# TDECQ changes (and consequent spec changes) for SMF and MMF clauses

Revision 1a

802.3cd, Berlin, Germany, July 2017

Jonathan King, Finisar

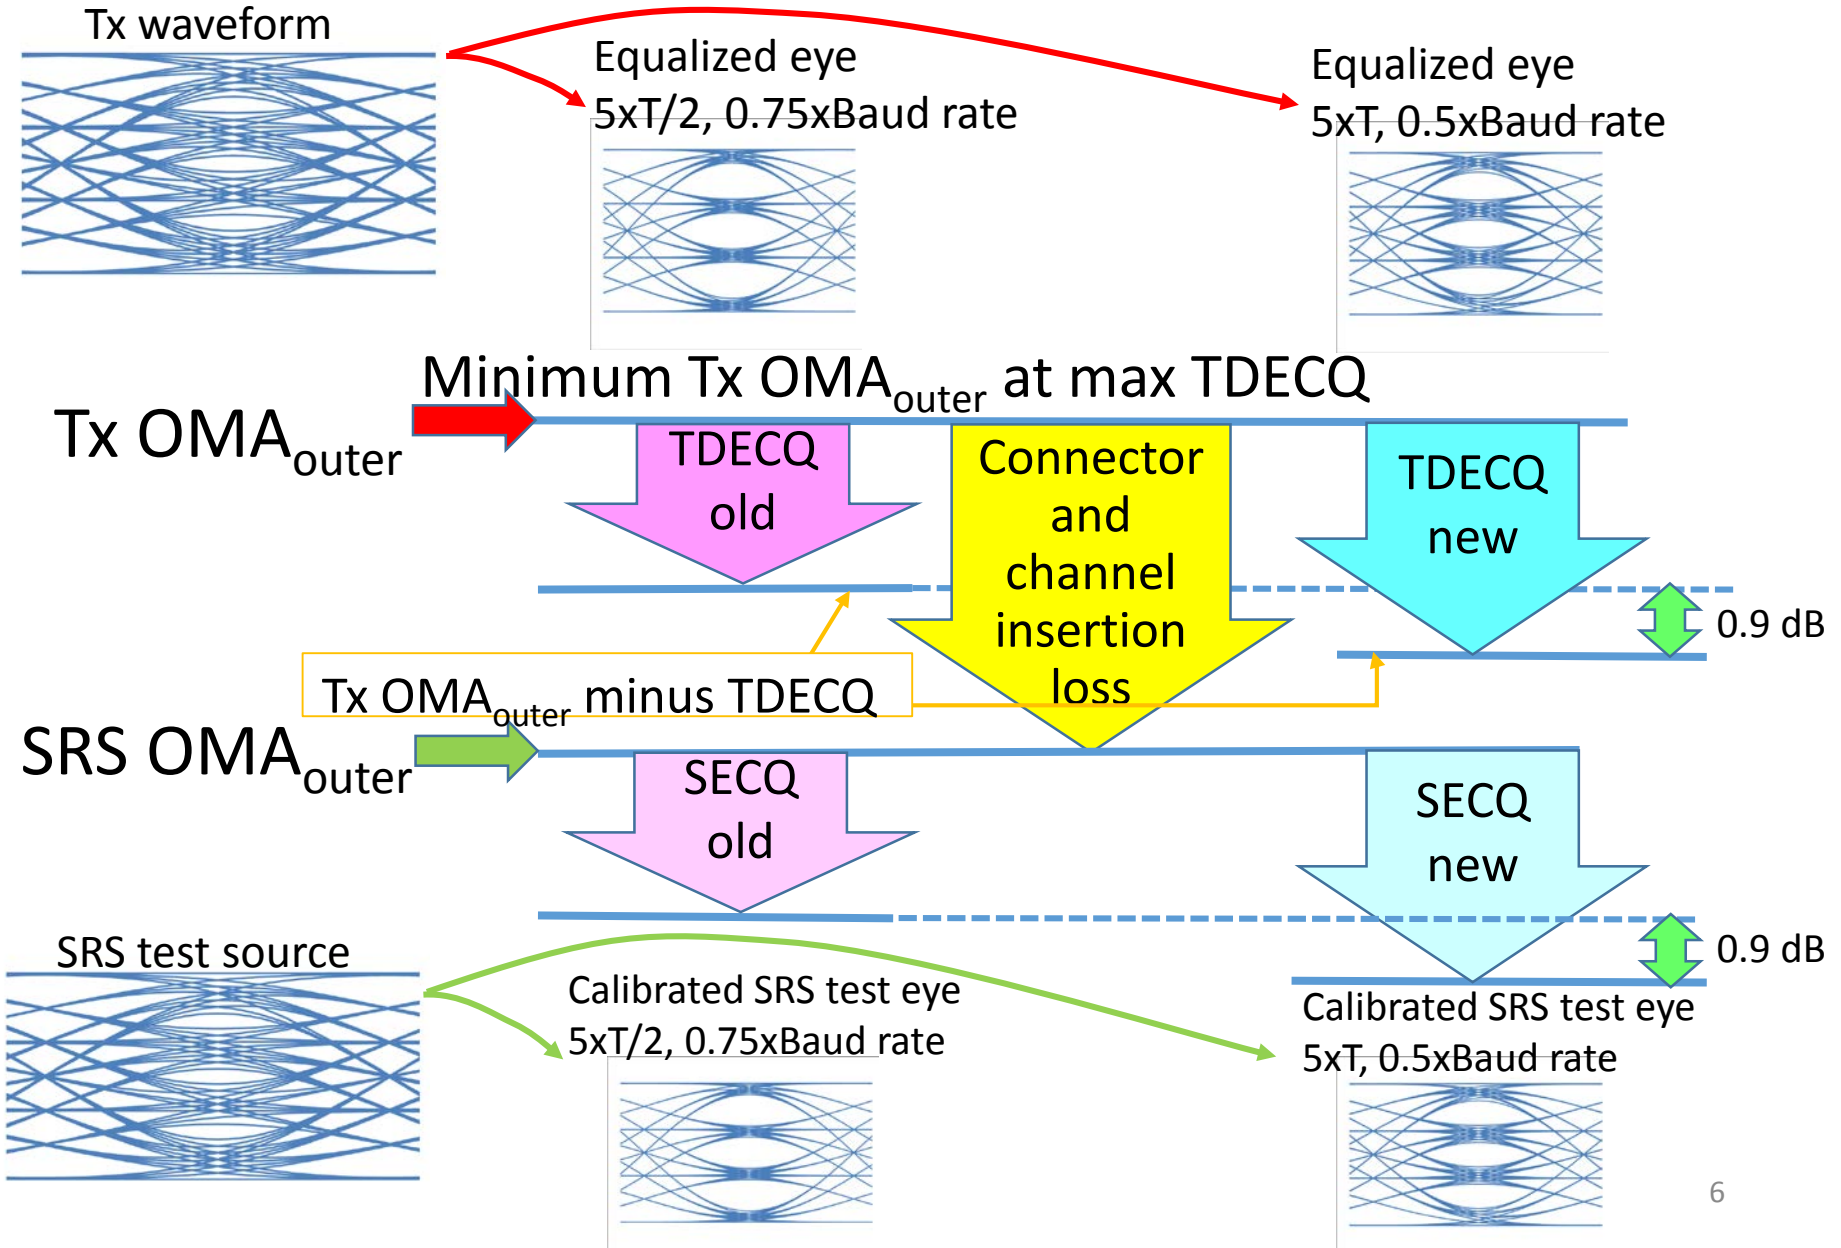
*Changing the TDECQ methodology doesn't change the transmitter characteristics, it's the same transmitter, but it's TDECQ is **measured** as larger for D3.2 TDECQ.*

*The change to SECQ doesn't change the stress applied to the SRS test source, but it's SECQ is measured as larger for the D3.2 SECQ.*

*A specific receiver implementation isn't changed by the D3.2 SECQ - it's still the same receiver. If it could equalize and close the link with the SRS test source calibrated with D3.1 SECQ, it will still close link with D3.2 SECQ, without needing to change the input OMA to the receiver.*
